MUNICIPAL CORPORATION,
KARACHI

RENEWAL OF PARTITIONS & FLOORING ON PLOT NO. 65.
M.M. 6. MACHHI MEANI QUARTER.
SCALE 8 FT = 1 INCH

With reference to your application dated 21-5-38
with a plan for the proposed ~~building~~ renewal of partitions & flooring in plot
No. 65 Survey Sheet No. M.M.6, Machi M. Quarter,
I have to request you to comply with the following requirements:—

Case No: B. S. P. 10/38.

SITE PLAN
SCALE 40 = 1 INCH

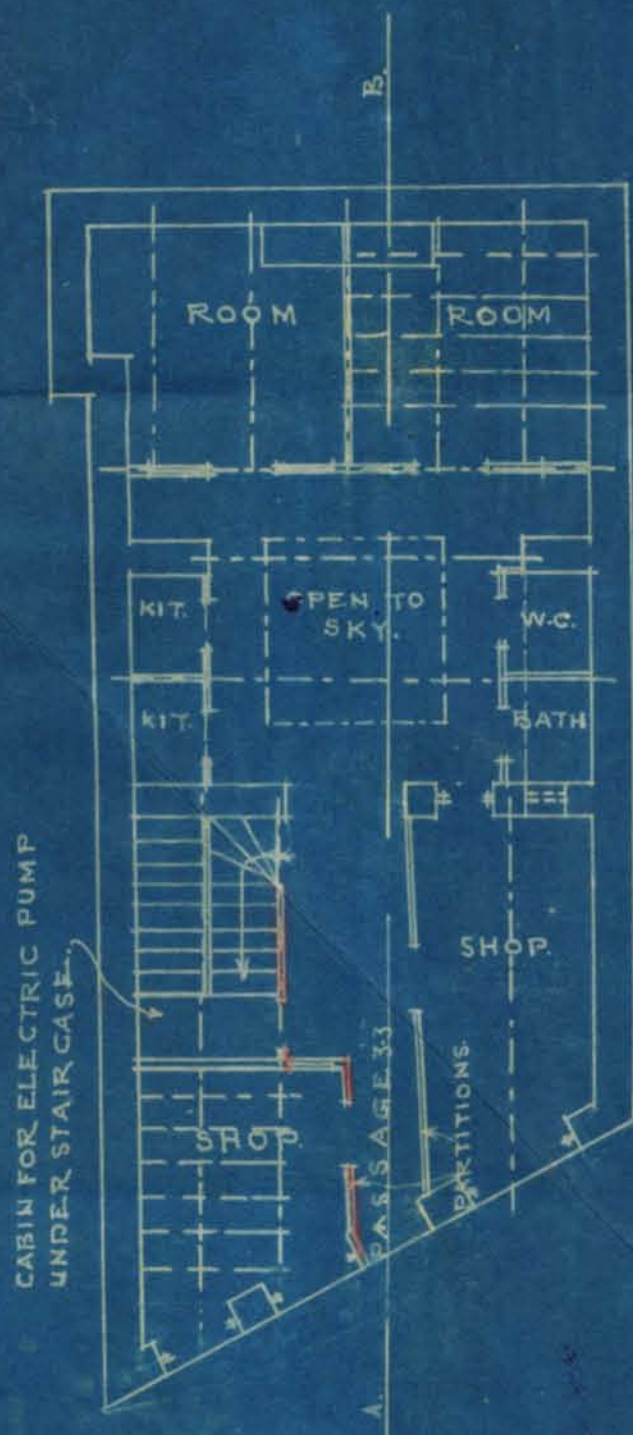
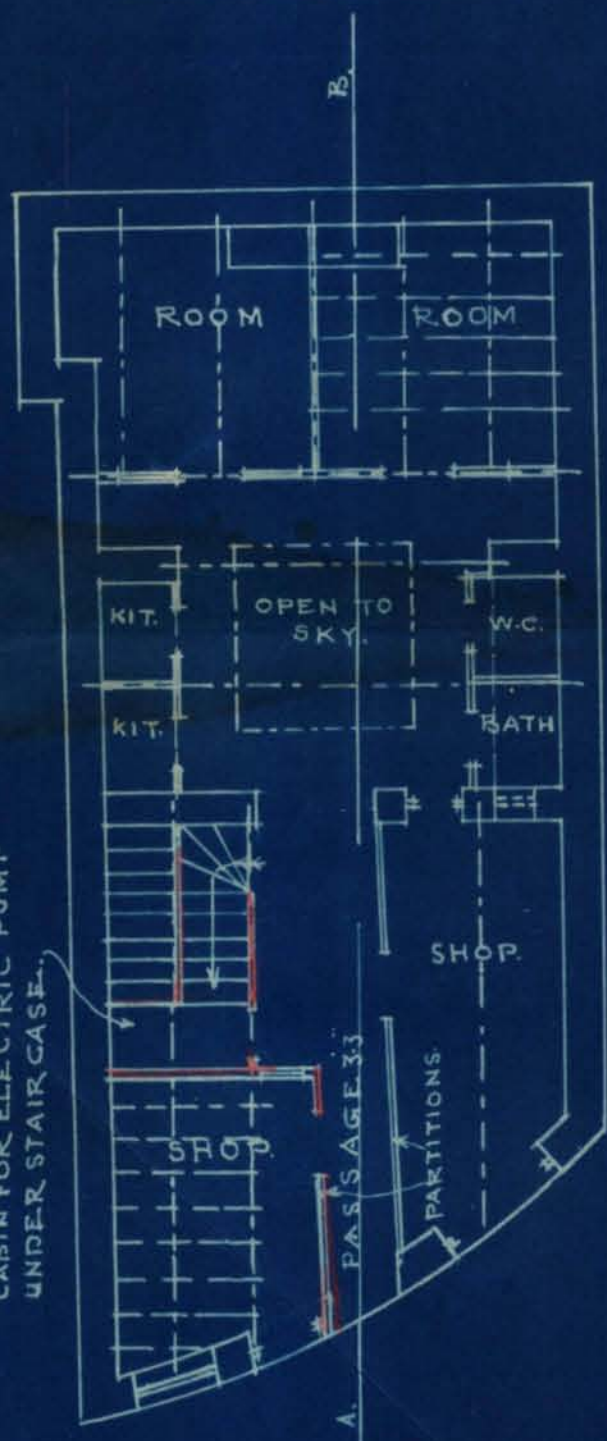
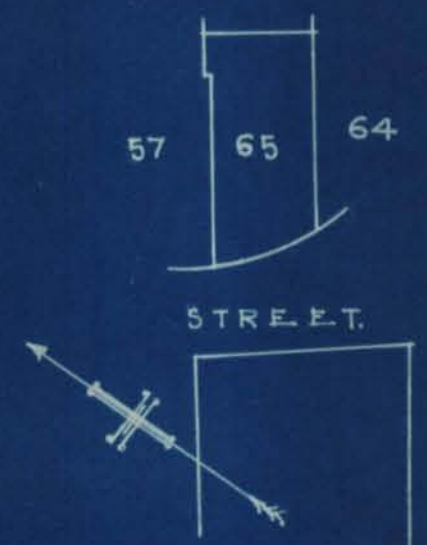
Land Surveyor's objection.

1. South west boundary of the plot to be made straight.

South west boundary of the plot to be made straight.

*L.S.
Side measurement of
the plot & width of
street are not shown on
the site plan. Please add it
necessary.*
Head Draftsman

- (1) Southwest boundary has been made straight.
- (2) width of the street is as essential as there is no change in height of the old building. The height has been altered and so the side adjoining height should not be enforced in this case of existing structure.
- (3) Kitchen and wooden staircase is being removed.
- (4) wooden partition in the room in South wall corner has been shown in the plan. The area of the room is more than 110 sq ft and it's merely a wooden screen to keep the room clean. Kitchen & other miscellaneous plan the objection may please be waived.
- (5) emphasized with

GROUND FLOOR

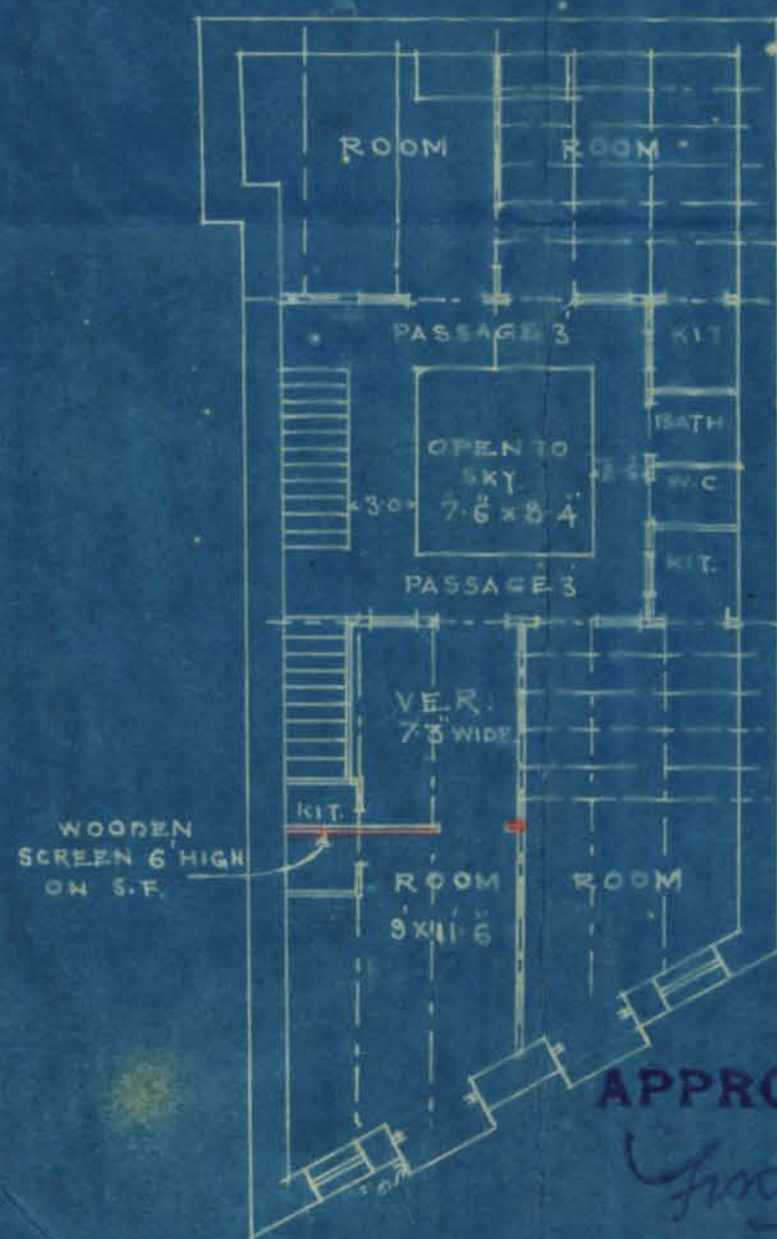
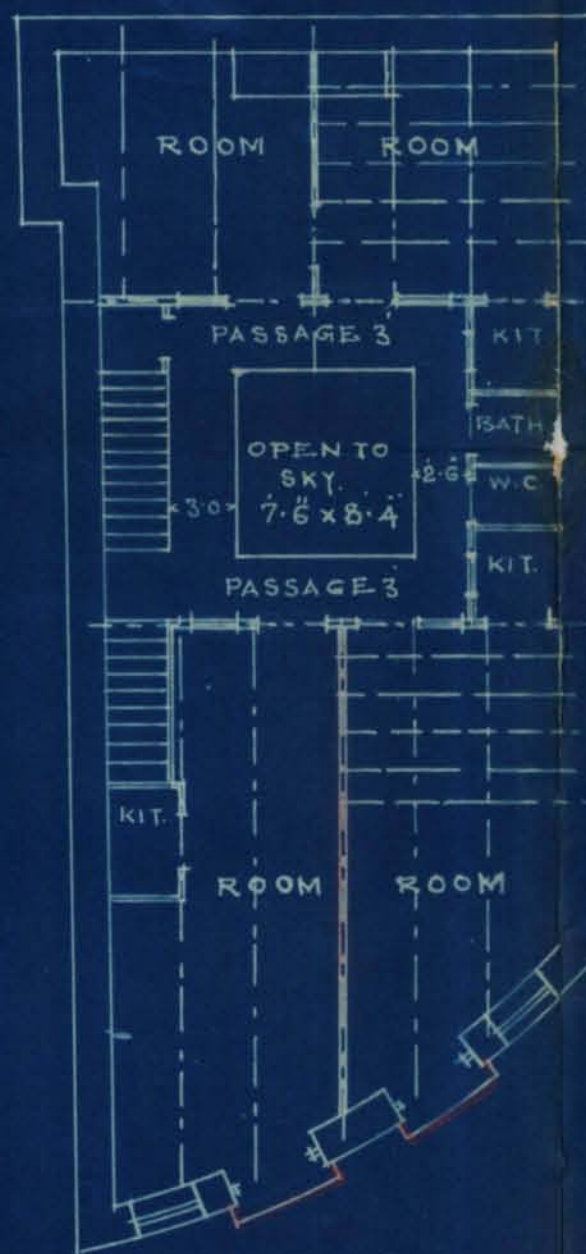
The kitchens under staircase be removed after which
the ~~plan~~ plans can be considered.

Ask the architect to
get the kitchen under staircase
removed, after which only the plans
can be considered.

2. Width of street to be shown and jointly checked with Land Surveyor. Height of building to be regulated accordingly.
3. Kitchens under wooden staircases can not be allowed.
4. Wooden partition in the room on 2nd floor at N.W. corner to be removed,
5. Room & store in the rear on the 3rd floor be dimensioned and all the U.A. work, carried out to be coloured to see if the same can be allowed.

1. Width of Street to be shown and jointly checked with D.S.
Height of building to be regulated accordingly.
2. Kitchens under wooden stair case cannot be allowed.
3. Wooden partition in the room on 2nd floor at N.W. corner to be removed.
4. Room & store in the rear on the 3rd floor be demarcated
And all the V.A. work, carried out to be coloured red
to see if the same can be allowed.

With reference to your letter no C.P. 10/38 dated 16-6-38, I have to inform you that the kitchen under the staircase have been removed as desired. The plans may, therefore, please be approved.

The kitchen below stair case has been removed.
For the V.A. work done, as the structure (timber) is old, ~~there~~ there is no objection to allow these.
V.A. f.c. is attached. & B. 4/7
